Product change notification (PCN)

Title / short description	Programming adapter update
Affected article category	Measurement and control technology
Change category	Form and appearance
Change number	CCK220170-00
Reason for PCN/PDN Revision

CCK220170

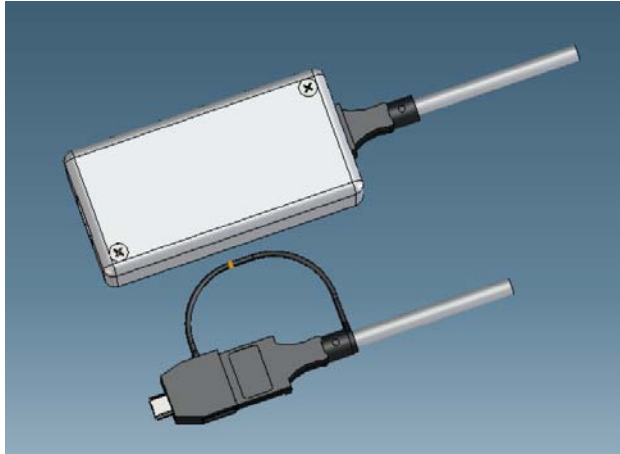
The IFS-USB-PROG-ADAPTER programming adapter (2811271) is extended, allowing it to be used with several device types from Phoenix Contact.

The main connecting cable to the signal conditioner and measuring transducer is replaced by a micro USB cable, allowing parameterization of the MINI Analog Pro and MINI Analog device series as well as most MACX Analog device series. In addition, 2 attachment adapters are supplied, which are required for parameterization of the MACX Analog AP (Additional Portfolio) device series and other MACX Analog device series. The additional attachment adapters extend product compatibility of the programming adapter. The new revision of the programming adapter is a full replacement of the existing revision.

Current status (2811271-07 / IFS-USB-PROG-ADAPTER)

New status (2811271-08 / IFS-USB-PROG-ADAPTER)
